G.O. No.	731	Press
		Mis.
13539	Dated 9th April	1872.

*Proceedings of the Madras Government, Public Works Department,
9th April 1872.*

Calingulahs.—I have the honour to forward the under-mentioned plans and estimates amounting to Rupees 60,000 for the enlargement of the calingulahs, and I request you will be so good as to submit them to the Government for sanction.

Planks successively moveable to be used at first
Without stands or screw gearing

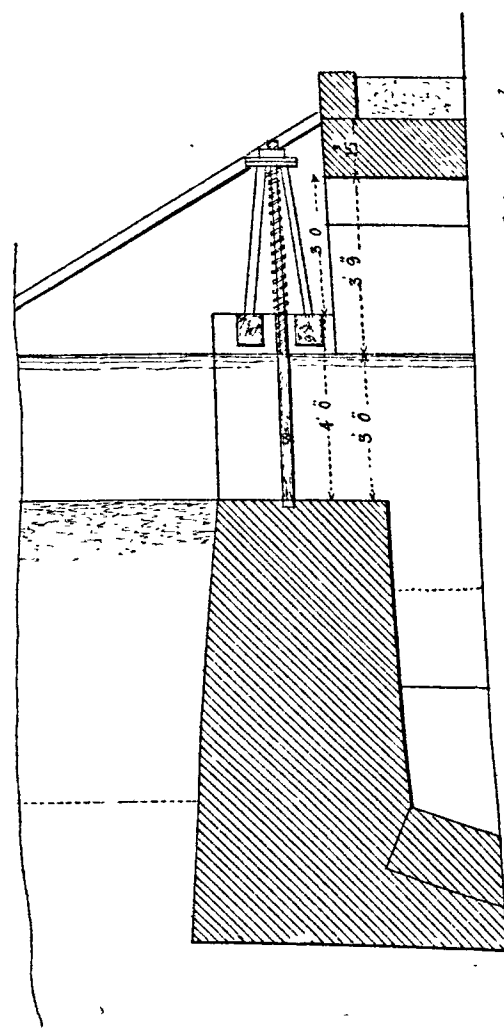
4. Taking all the above into consideration, I should certainly be inclined to favour the second arrangement mentioned in Mr. Browning's letter, where the crest wall of the calingulah is thickened and the planks are placed in advance of the arches and are visible from the tow-path. The lower portions of the piers are extended to hold the planks, and as they may be built up to any height, there is no obstacle to the addition of screw lifting gear at any future time. The gear might be carried on timber beams in pairs with a space between them sufficient to allow of the shutter passing up to the shoulder of the stand, which could thus be placed at a small height above the level of the water, and the screw would be worked by men standing on the beams clear of the water.

Of course the grooves for the plank must be vertical instead of slanting, as shown in drawing No. 1 forwarded with the letter above alluded to. It would be sufficient if the shutter when raised cleared the water at full supply level by 1 foot. I should be glad if the Chief Engineer would state whether he can suggest any objections to the arrangement as sketched above and shown in the margin in outline.

2. The arrangement proposed by Captain Scott is a very good one and can be adopted; I have, therefore, the honour to beg that the scheme may now be sanctioned with an addition of Rupees 6,530 to the estimate already submitted by me as explained in paragraph 3 of my letter No. 84 of 10th instant.
